Title: Advisory Committee on Reactor Safeguards
 AP1000 Reactor Subcommittee Meeting
 Open Session

Date: Friday, November 19, 2010

AP1000 REACTOR SUBCOMMITTEE MEETING

Section 23.W – Changes to Add a Vacuum Relief System to the Containment

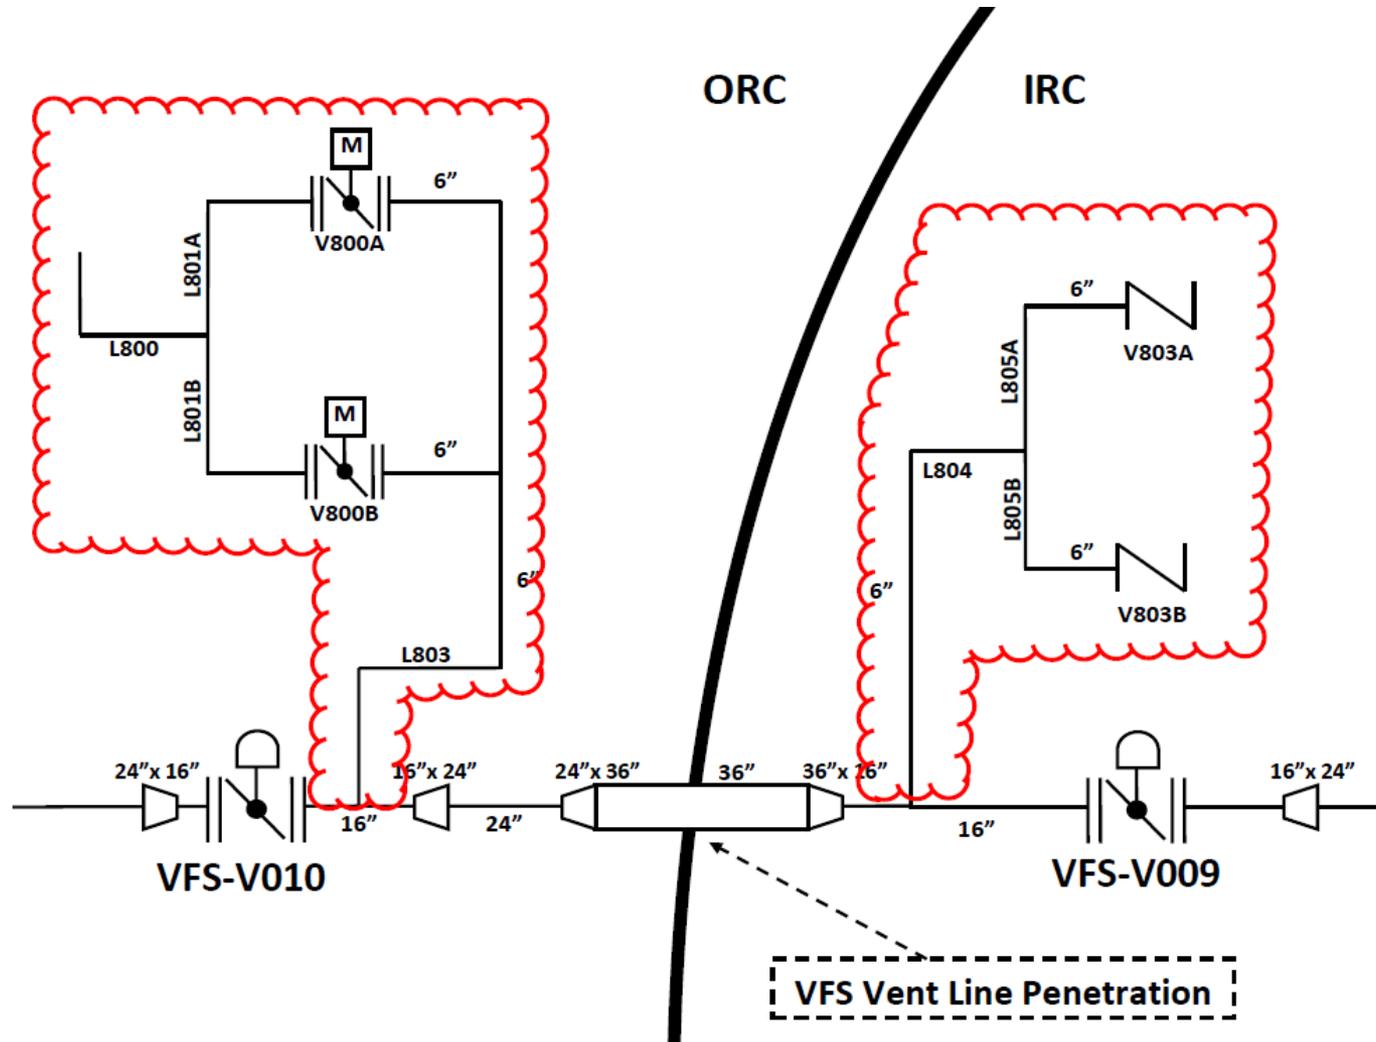
- Proposed design changes
 - Add a vacuum relief system to the containment to prevent external differential pressure between containment and the shield building from exceeding the design value
 - Reduce external pressure design limit from 2.9 psid to 1.7 psid
 - Add Technical Specification 3.6.10, Vacuum Relief Valves, to provide assurance these components will adequately perform their functions.

Vacuum Relief Piping Arrangement

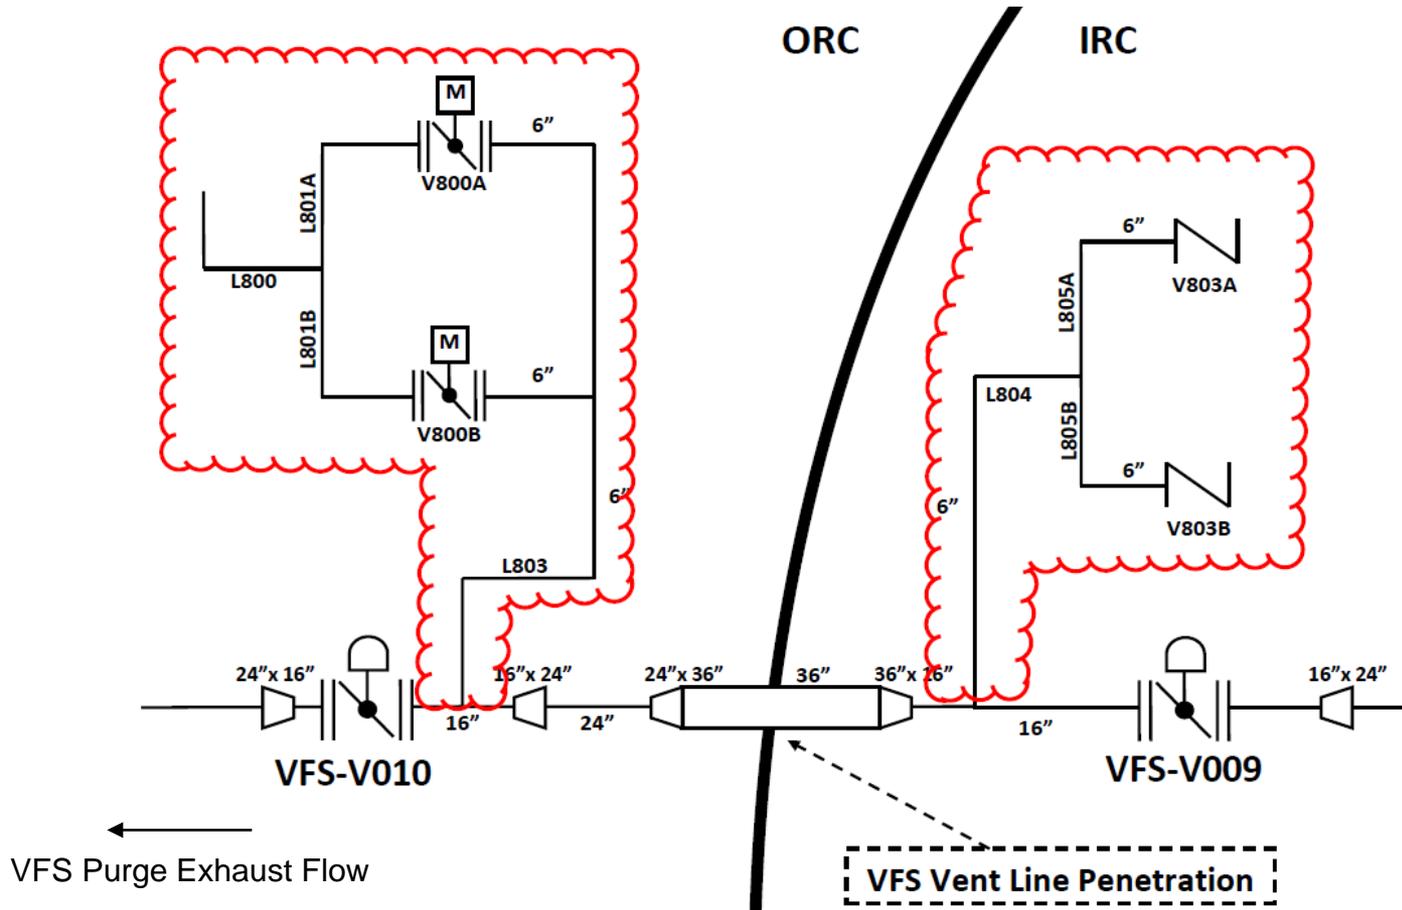
2 This is a diagram that shows a vacuum
3 relief system was added. What I wanted you to do was
4 kind of look at that diagram. And I'll go through the
5 second slide, which is an overview of what the changes
6 were.

7 Fundamentally we added -- using existing
8 purge exhaust penetration, we added outside of
9 containment two parallel butterfly-operated valves and
10 inside containment two parallel check valves that are
11 balanced check valves opened with a slight pressure.

7 We identified a containment over cooling
8 event that required the addition of this system in
9 looking at our design. And, consequently, we added a
10 six-inch vacuum relief-sized system that's shown on
11 the other drawing.

12 The schematic of these meets the ASME
13 section 3 criteria, NE 771.52, for a vacuum relief
14 device for the containment vessel itself. So it's
15 designed to be consistent with that. And, actually,
16 as I'll show you later, it's similar to the
17 configuration of current plants that have the steel
18 shell containment like we do.

23 The arrangement is, as you have seen in
24 the other drawing, two MOV butterfly valves. They're
25 class 1E butterfly valves with an actuation signal to
